ADDENDUM NUMBER TWO

Indiana University Launch Accelerator for Biosciences 1302 Indiana Ave. Indianapolis, IN 46202

Addendum Dated: OCT 21, 2025

IU Project #: 20250072 BSALS Project #: 00360481

1 TYPICAL BASE PLATE DETAILS
1" = 1'-0"

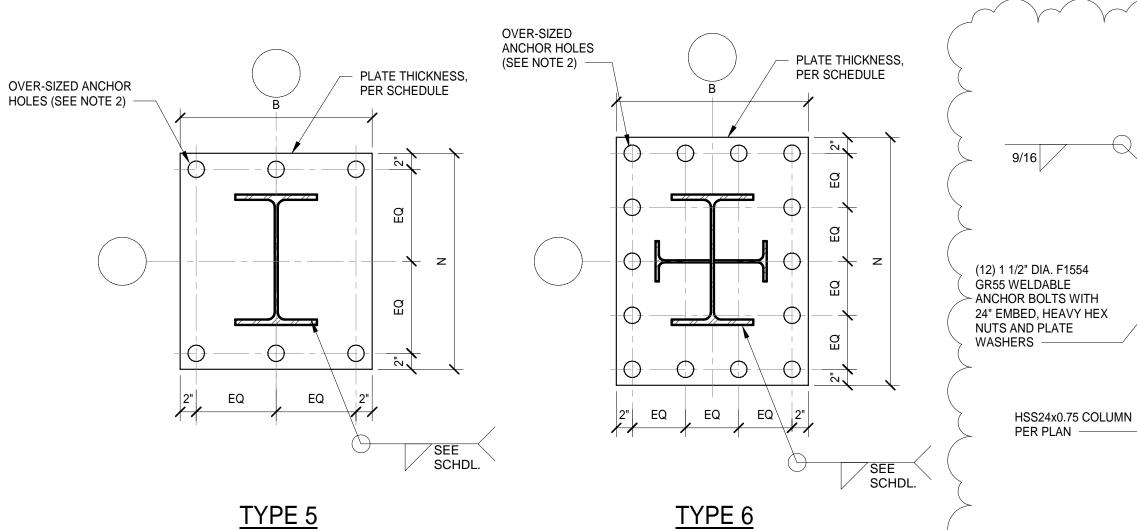
- 20. Sheet Figure 11
 - a. New Sheet
- 21. Sheet S007
 - a. Add base plate detail TYPE 7 for a round column as shown on the clouded portion of the attached revision drawing.

S110A

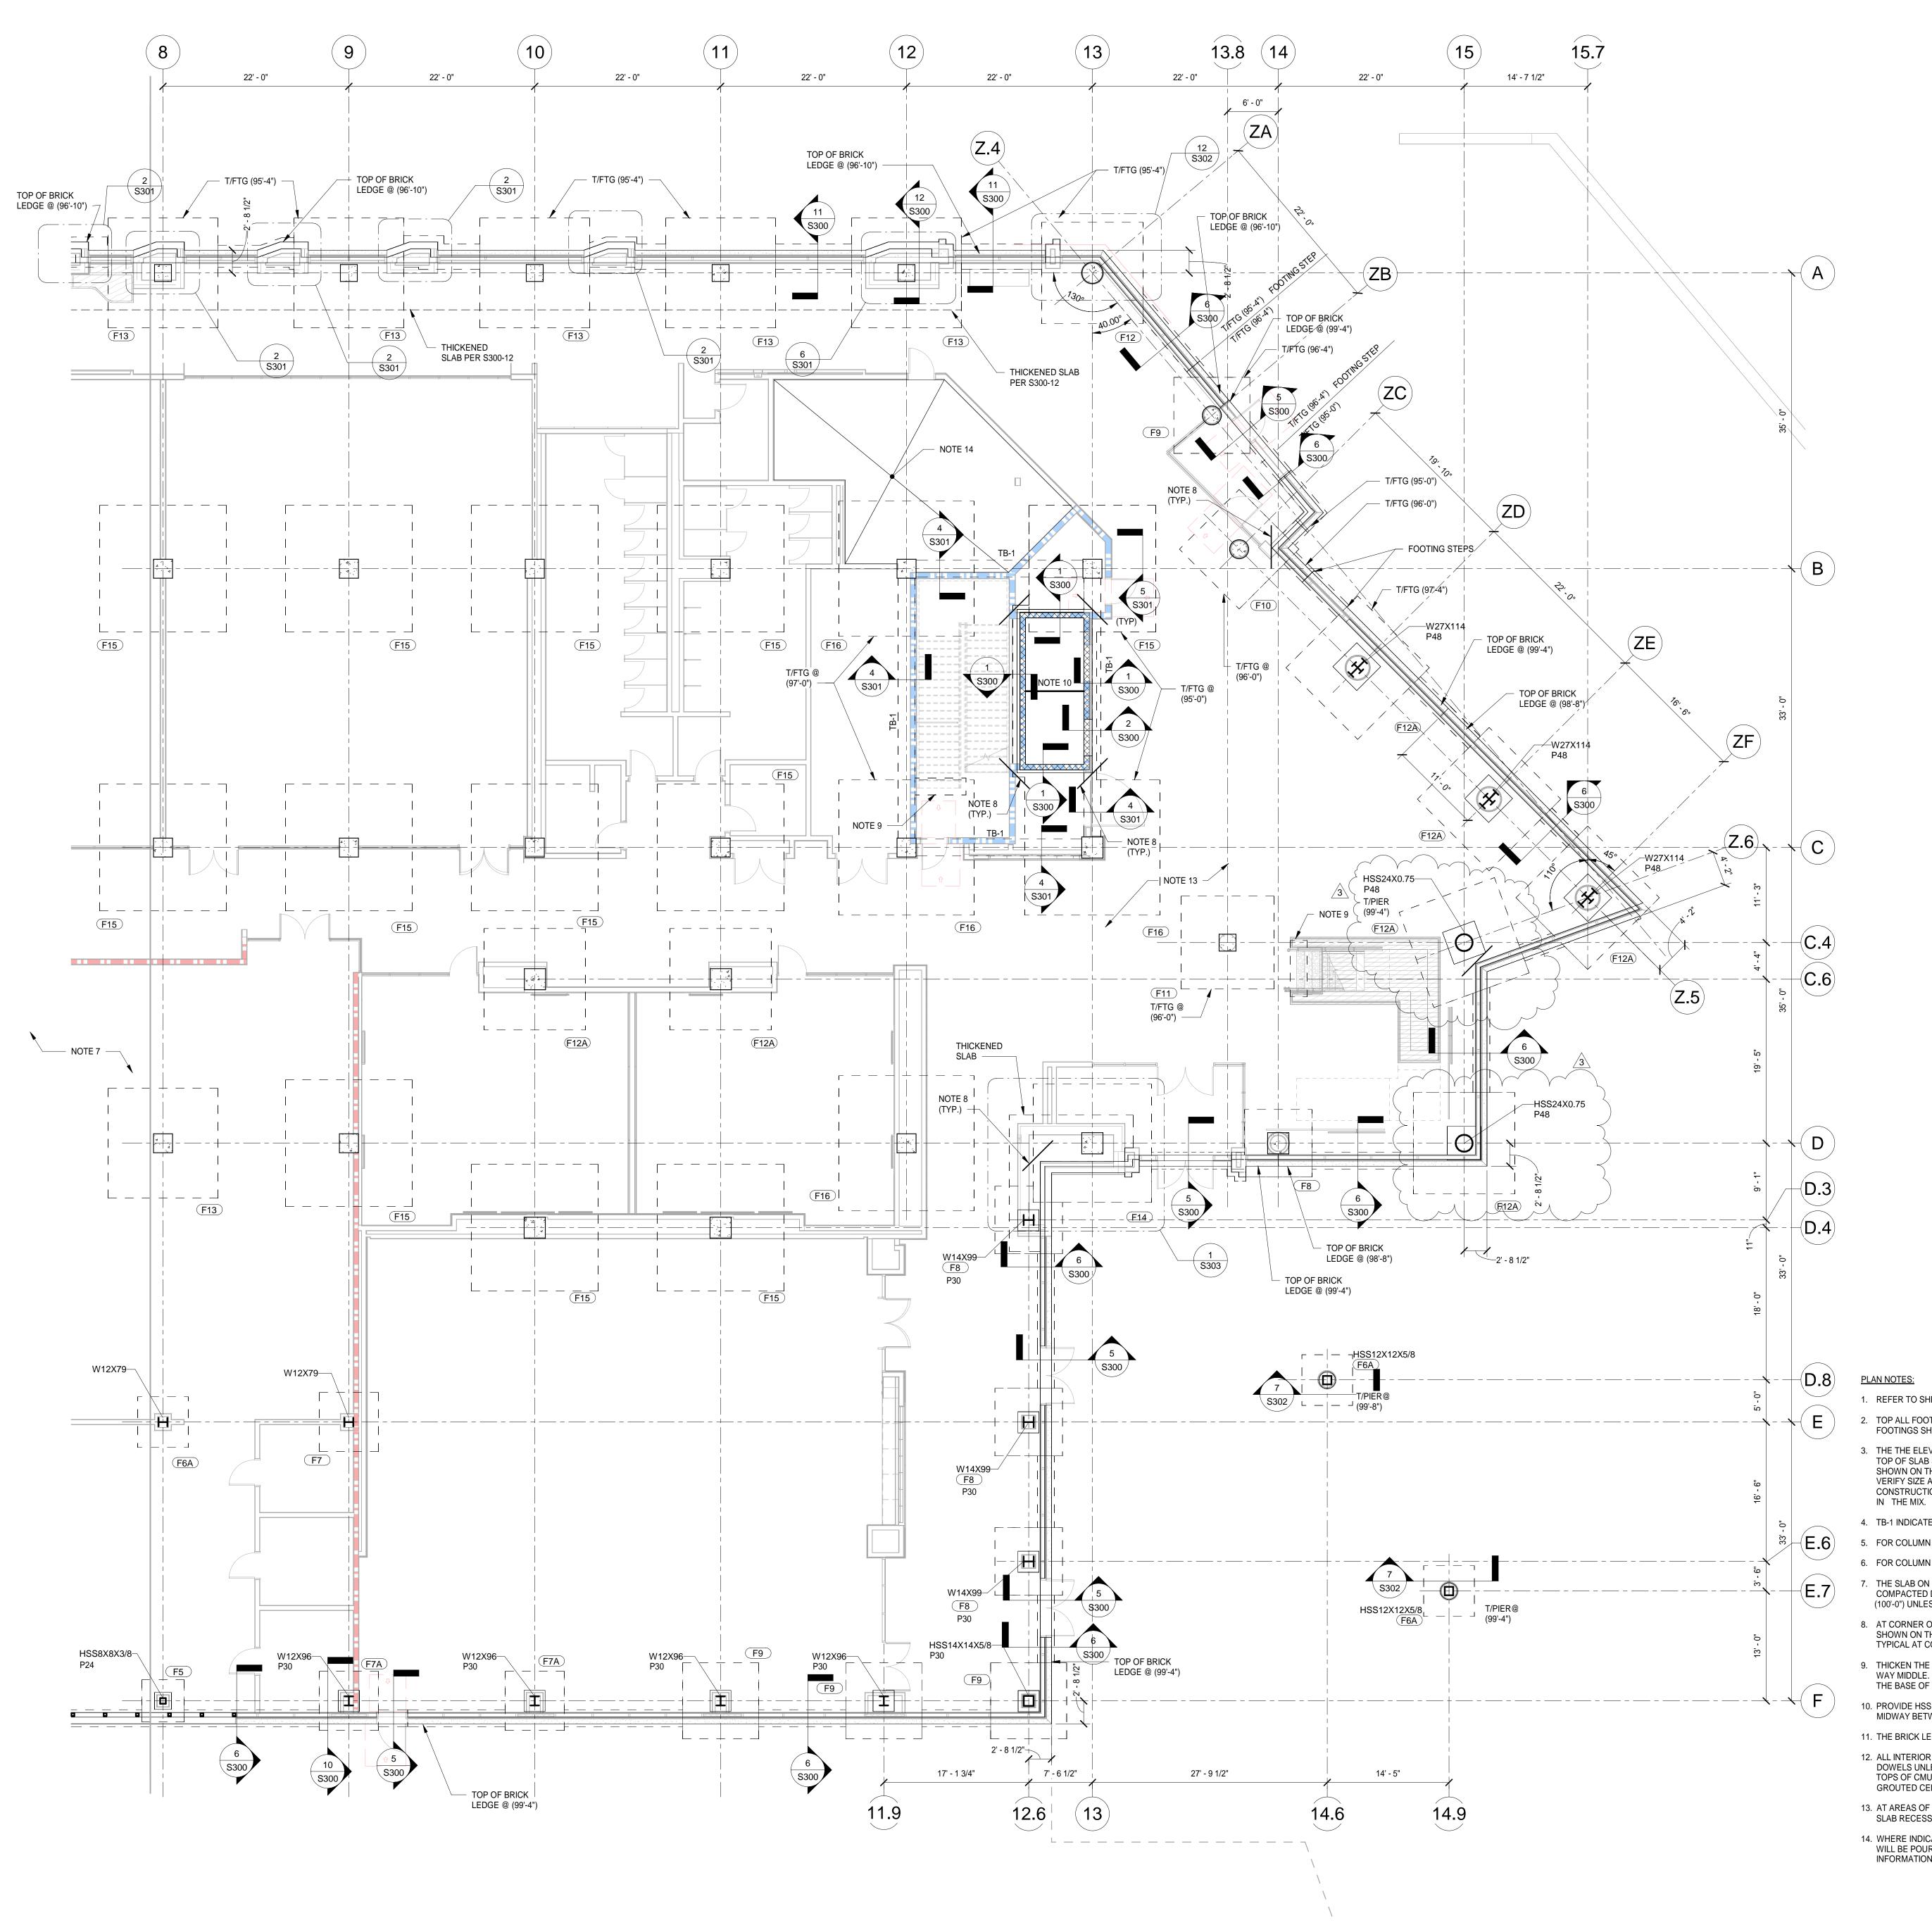
- 22. Sheet S110A
 - a. Add footing steps along the west face of the building to accommodate a water line, per the clouded portion of the attached revision drawing.

- b. Add a row to the base plate schedule for the 24 inch diameter column as shown on the clouded portion of the attached revision drawing.
- 23. Sheet S110B
